CLEPA proposal to define areas on the ECRS which should be marked for intuitive belt routing

March 09, 2017. CLEPA Offices

Marking requested if: "The direction of the belt is changing more than [45 degrees]."

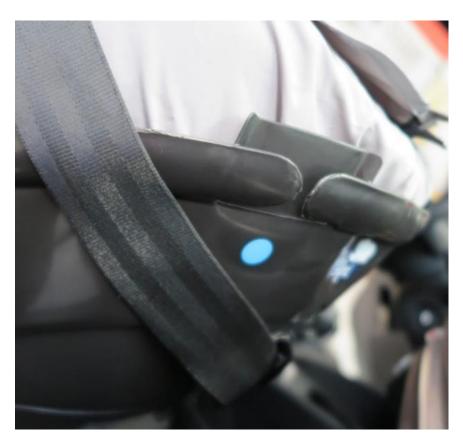
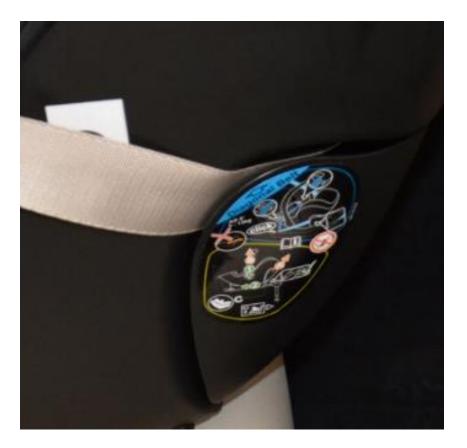
Angle change < 45 degress ► No marking

Angle change > 45 degrees ► Marking of belt route

Requirement may cause the need of marks at the outer edges

Question: Eventual limitation of angle change to avoid to complex installation?

Marking requested if: "The belt is routed through the back rest or the base of the ECRS."

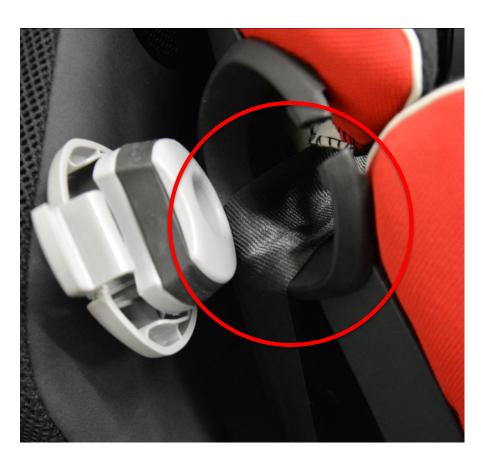
Belt should be routed underneath the back rest cushion

► Additional indicators may help?
